IOWA COLONY PLANNING COMMISSION
MINUTES OF MARCH 2, 2021

LETTER OF RECOMMENDATION

STERLING LAKES AT IOWA COLONY AND SIERRA VISTA PLAN OF DEVELOPMENT AMENDMENT #2

FIGURE 3

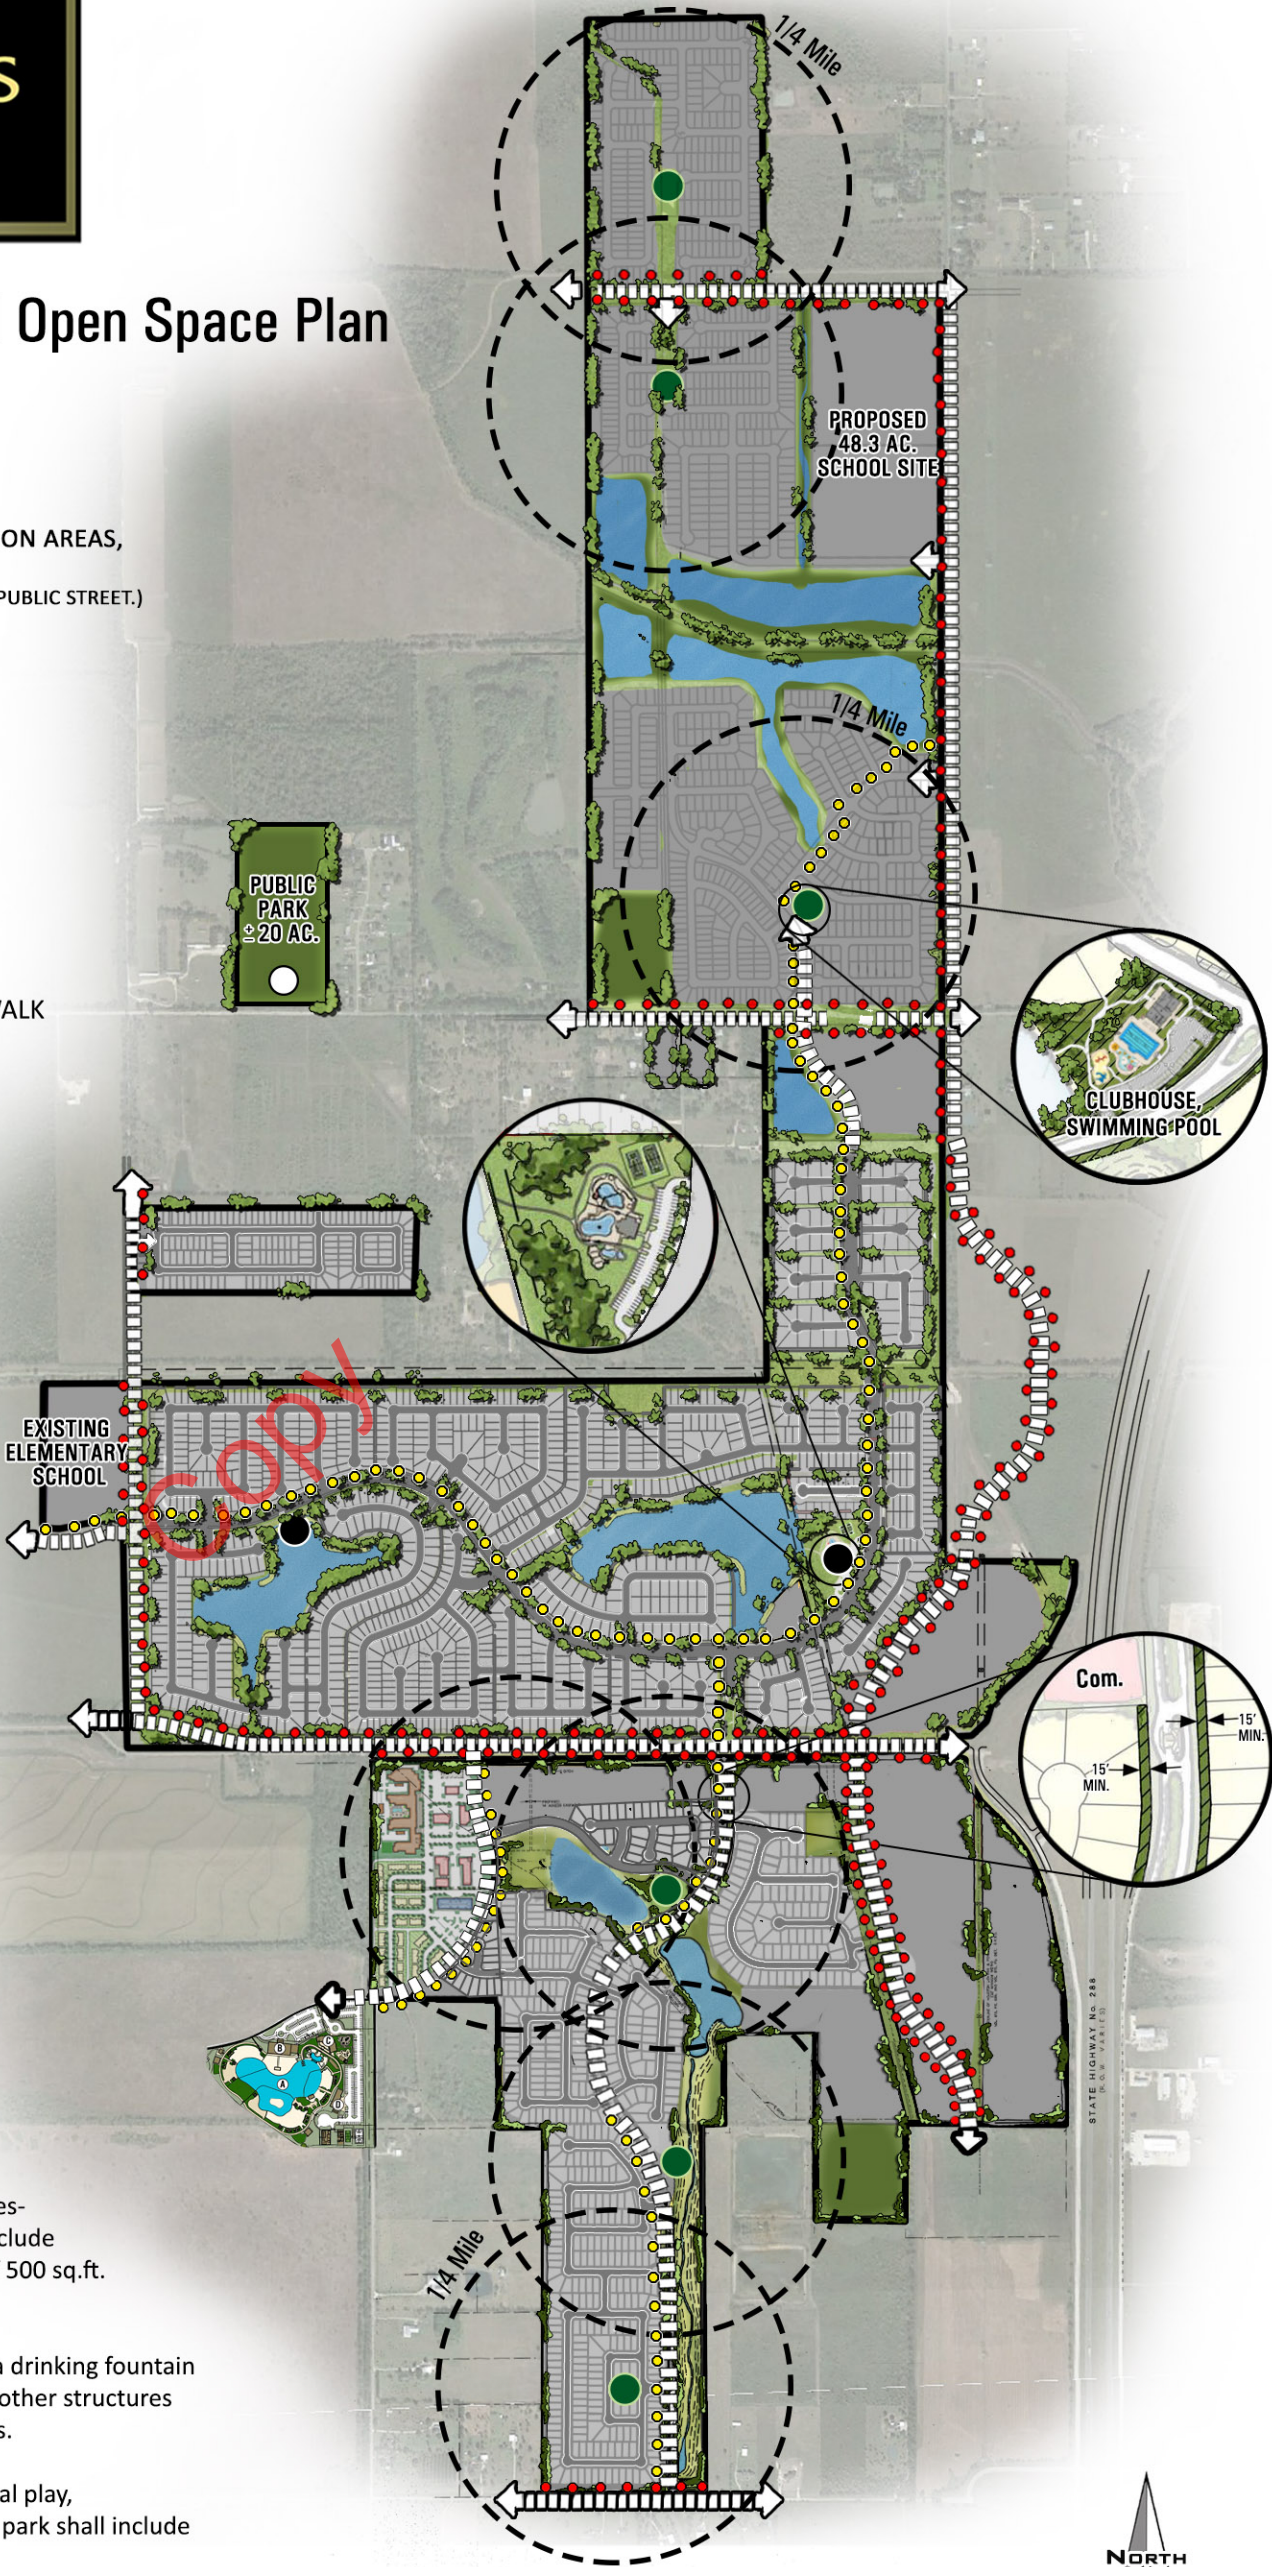
Figure 3 Contributing Landscape and Open Space Plan – Add a minimum 20 feet wide pedestrian reserve with a minimum 12 feet wide concrete multi-use path across the bayou between the residential area north and south of the bayou between Cedar Rapids Parkway and Bullard Parkway. Identify the exact location for the noted 2 parks with ball field facilities and the one park with a dog park

FIGURE 4

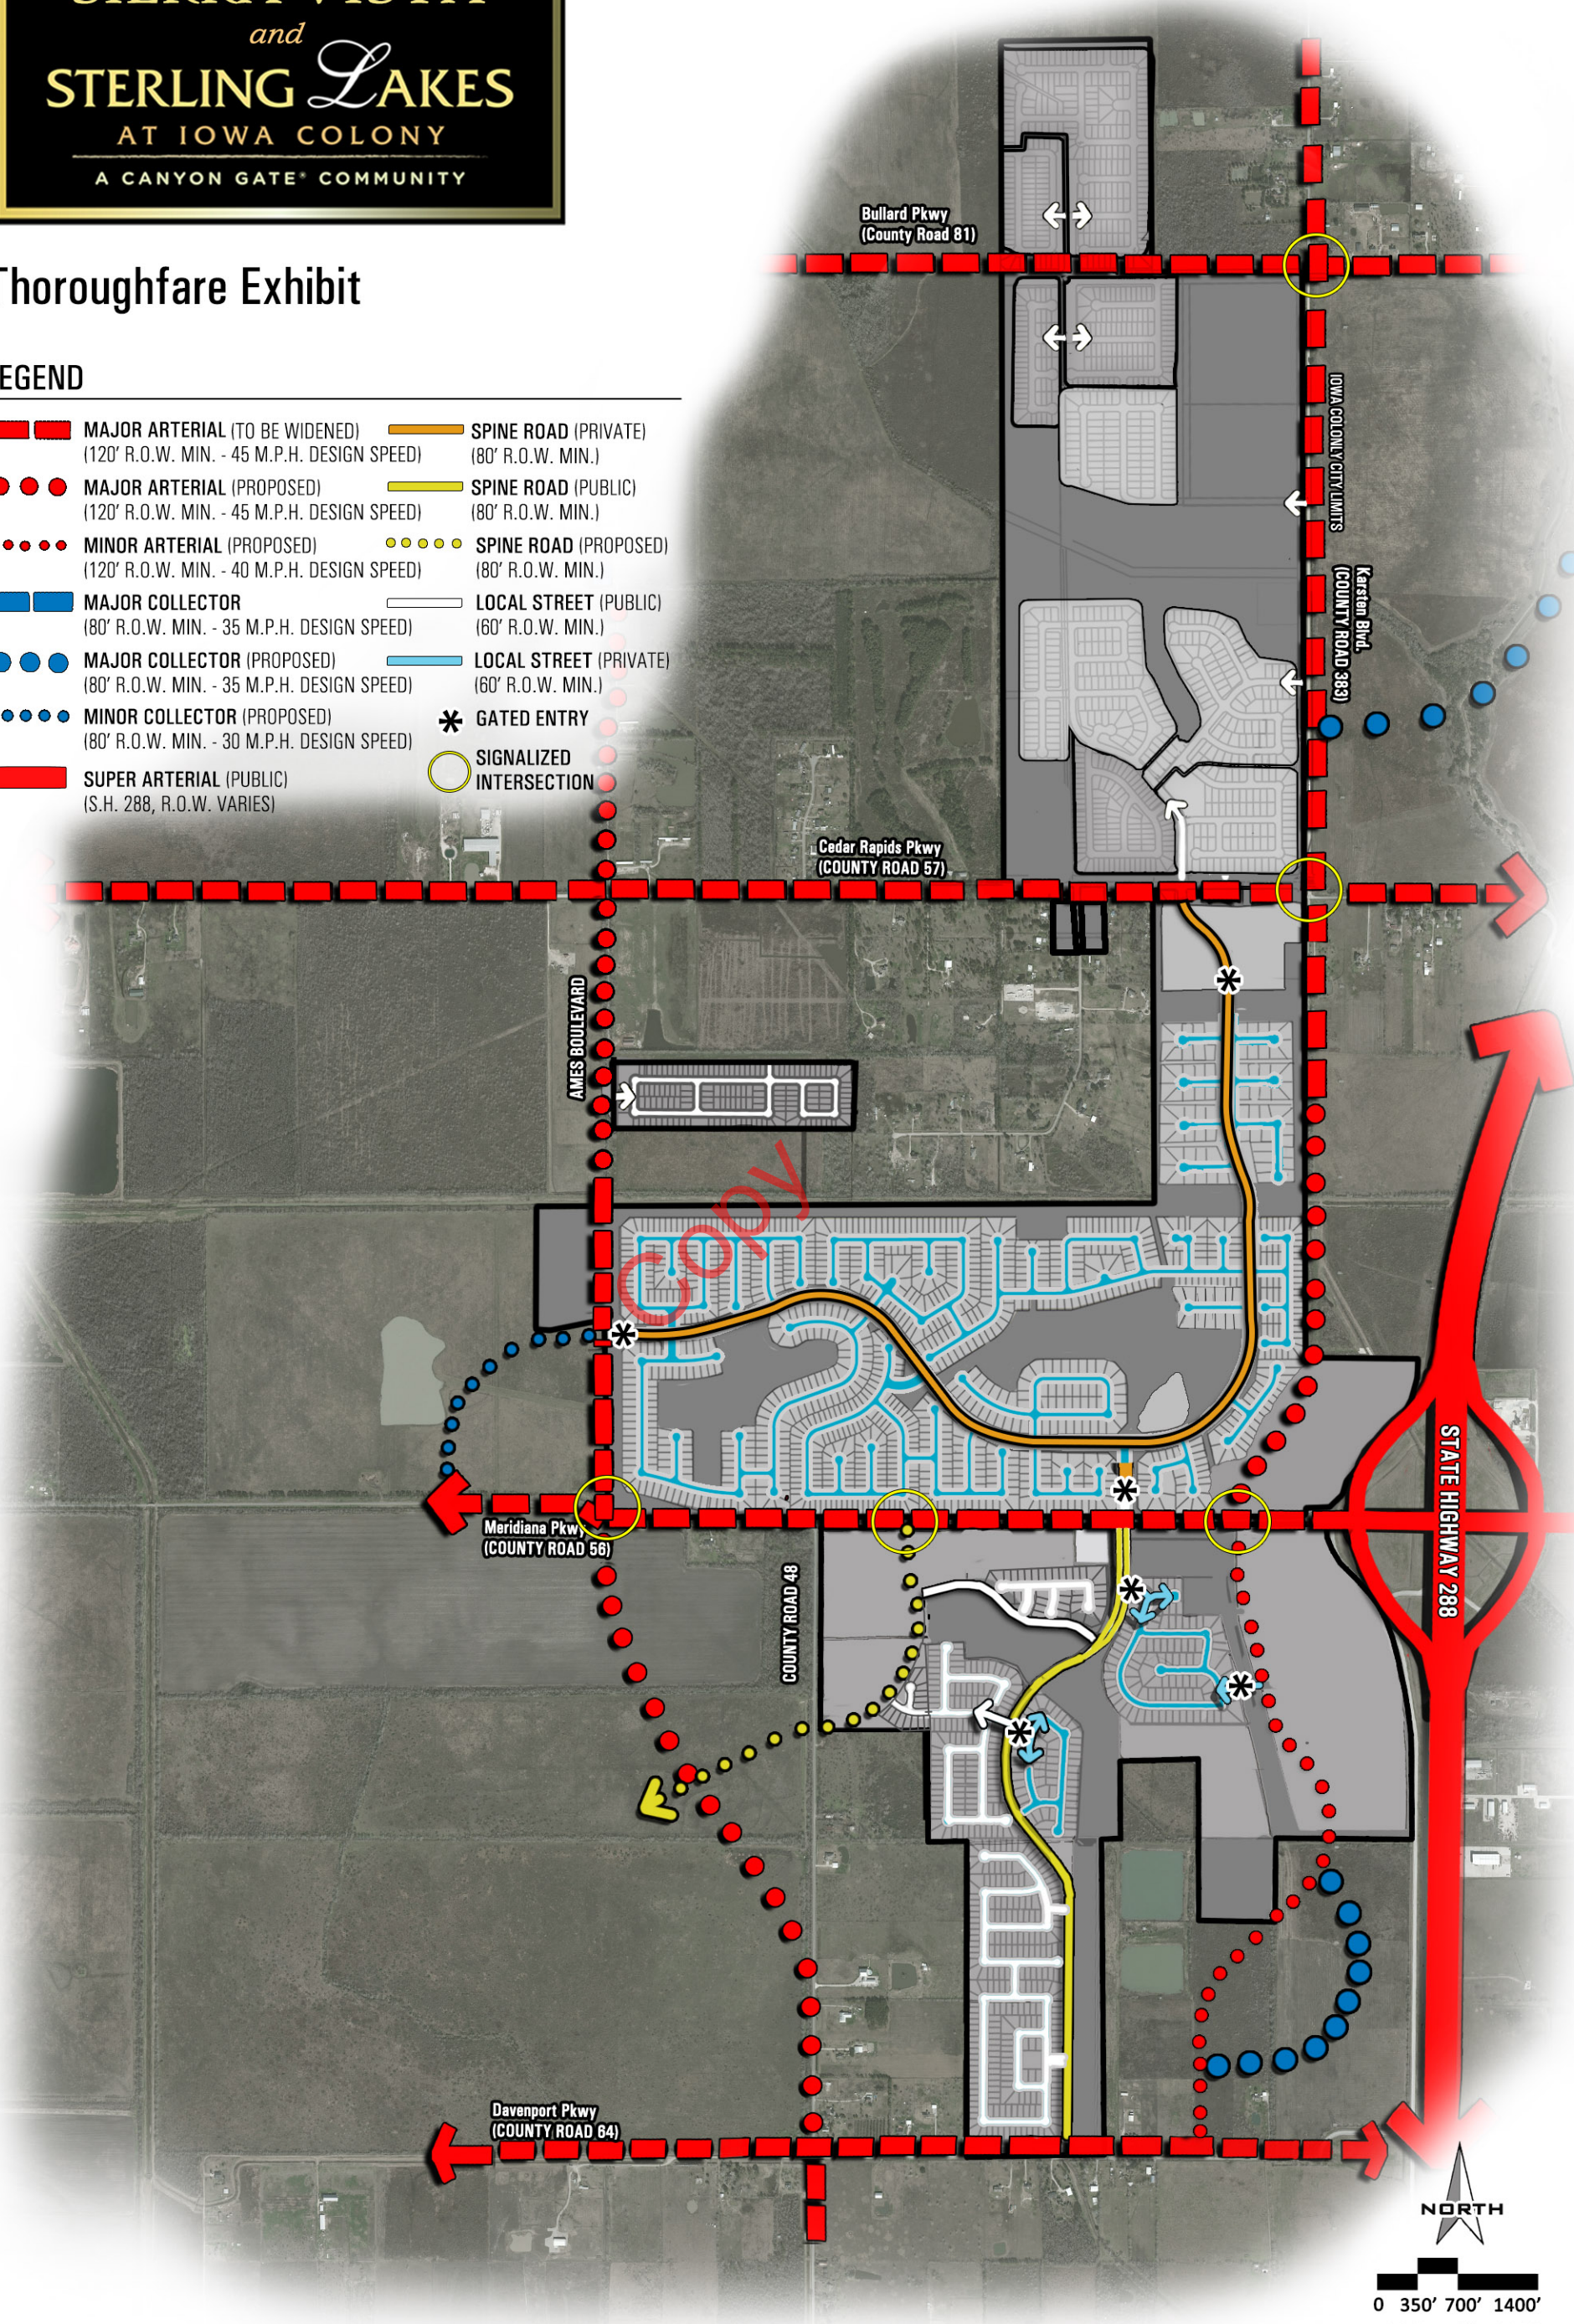
Figure 4 Thoroughfare Exhibit – Add a north/south minor collector connecting Cedar Rapids Parkway with Bullard Parkway just to the west of the west Sterling Lakes North property line.

FIGURE 5

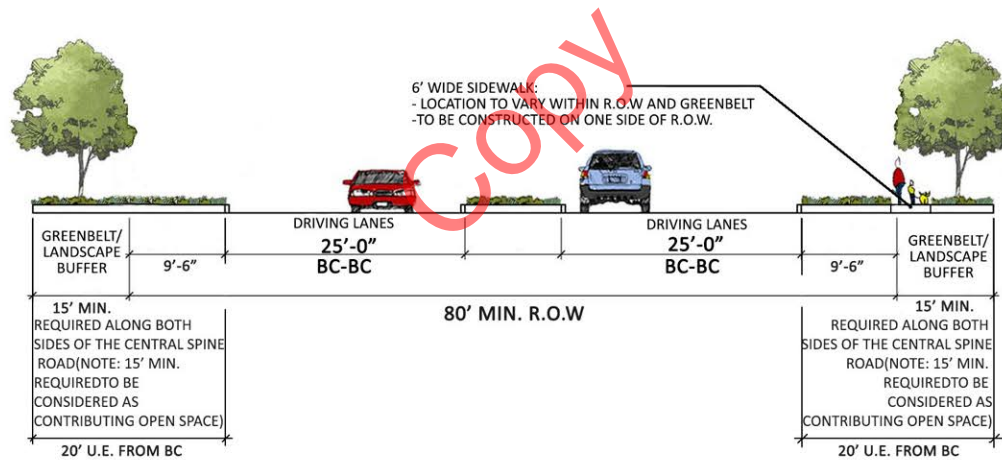
Figure 5 Spine Road Divided – Add a note that in areas adjacent to the Town Center District, sidewalks will be required on both sides of the spine road

FIGURE 6

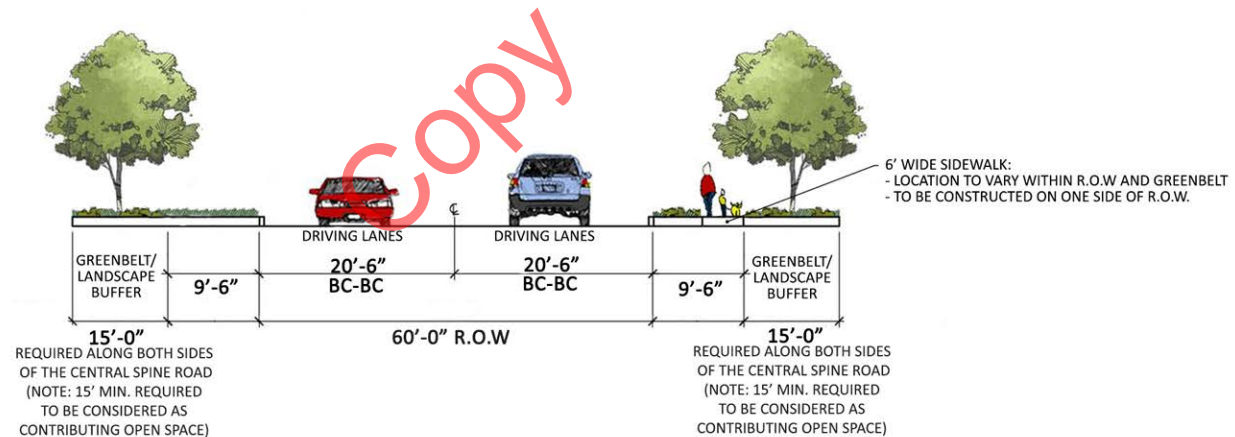
Figure 6 Spine Road Undivided – The Thoroughfare Exhibit does not indicate any 60 feet wide ROW. Change this ROW section to a minimum of 80 feet wide to conform to the Thoroughfare Exhibit.
